APPLICATION FOR PERMIT TO DRILL				5. MINERAL LEASE NO: ML 48178	6. SURFACE: State
1A. TYPE OF WORK: DRILL <input checked="" type="checkbox"/> REENTER <input type="checkbox"/> DEEPEN <input type="checkbox"/>				7. IF INDIAN, ALLOTTEE OR TRIBE NAME: N/A

2. NAME OF OPERATOR: ConocoPhillips Company				9. WELL NAME and NUMBER: Utah 33-1074	
3. ADDRESS OF OPERATOR: P.O. Box 51810 CITY Midland STATE Tx ZIP 79710			PHONE NUMBER: (432) 688-6943	10. FIELD AND POOL, OR WILDCAT: Drunkards Wash

**WORKSHEET
APPLICATION FOR PERMIT TO DRILL**

Well name:	4300731487000 ConocoPhillips Utah 33-1074	
Operator:	ConocoPhillips	Project ID:
String type:	Surface	43-007-31487-0000
Location:	Carbon County

Casing Schematic

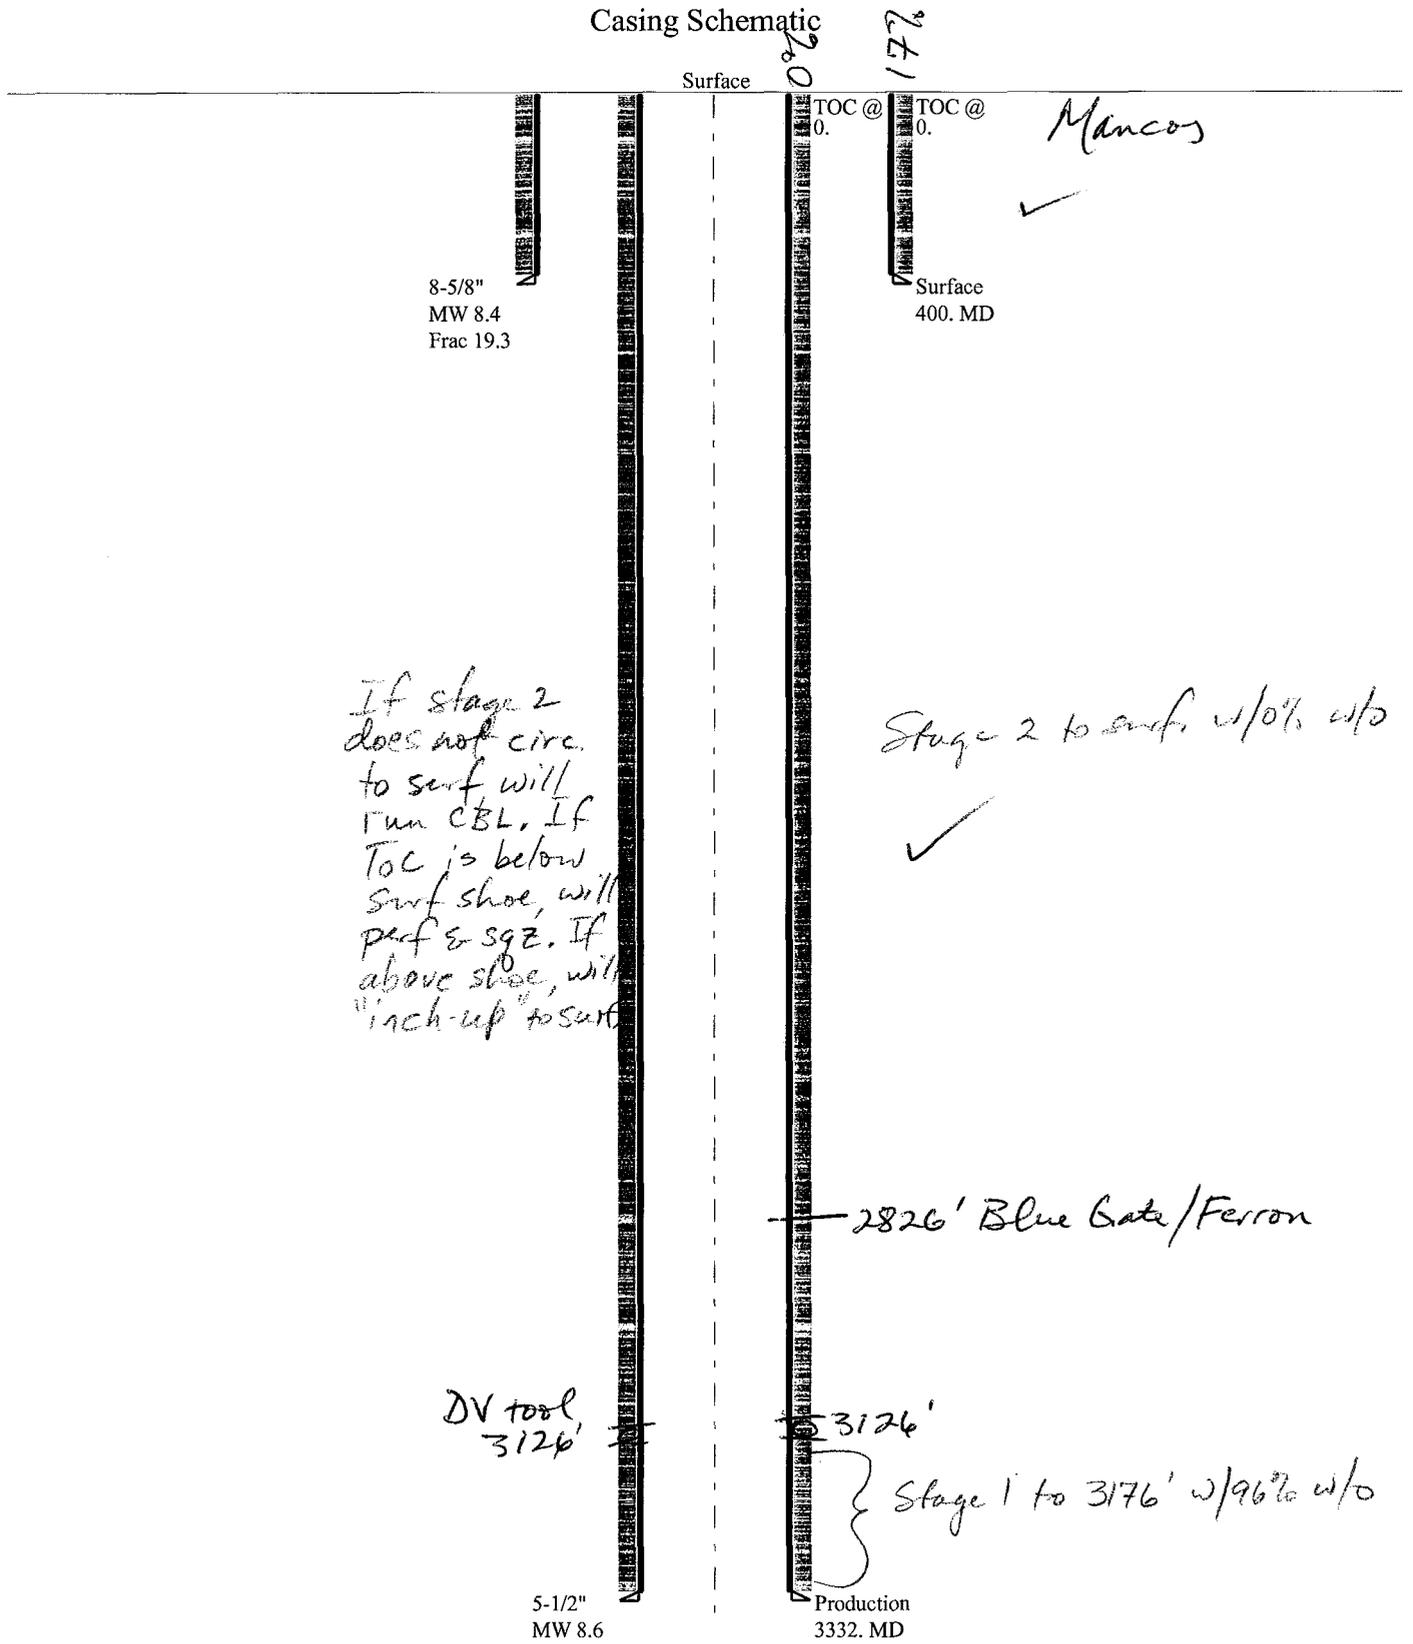
If stage 2
does not circ.
to surf will
run CBL. If
TOC is below
surf shoe, will
perf & sgz. If
above shoe, will
"inch-up" to surf.

Design parameters:	Minimum design factors:	Environment:
<u>Collapse</u>	<u>Collapse:</u>	H2S considered? No
Mud weight: 8.400 ppg	Design factor 1.125	Surface temperature: 65 °F
Design is based on evacuated pipe.		Bottom hole temperature: 71 °F
		Temperature gradient: 1.40 °F/100ft
		Minimum section length: 250 ft
	<u>Burst:</u>	Cement top: Surface
	Design factor 1.00	
<u>Burst</u>		
Max anticipated surface pressure: 352 psi	<u>Tension:</u>	Non-directional string.
Internal gradient: 0.120 psi/ft	8 Round STC: 1.80 (J)	
Calculated BHP 400 psi	8 Round LTC: 1.80 (J)	
No backup mud specified.	Buttress: 1.60 (J)	
	Premium: 1.50 (J)	Re subsequent strings:
	Body yield: 1.50 (B)	Next setting depth: 3,332 ft
	Tension is based on buoyed weight.	Next mud weight: 8.600 ppg
	Neutral point: 349 ft	Next setting BHP: 1,489 psi
		Fracture mud wt: 19.250 ppg
		Fracture depth: 400 ft
		Injection pressure: 400 psi

Remarks: Collapse is based on a vertical depth of 400 ft, a mud weight of 8.4 ppg. The casing is considered to be evacuated for collapse purposes. Collapse strength is based on the Westcott, Dunlop & Kemler method of biaxial correction for tension.

Collapse
 Mud weight: 8.600 ppg
 Design is based on evacuated pipe.

Max anticipated surface pressure: 1,089 psi
 Internal gradient: 0.120 psi/ft
 Calculated BHP 1,489 psi

Remarks:
 Collapse is based on a vertical depth of 3332 ft, a mud weight of 8.6 ppg. The casing is considered to be evacuated for collapse purposes. Collapse strength is based on the Westcott, Dunlop & Kemler method of biaxial correction for tension.
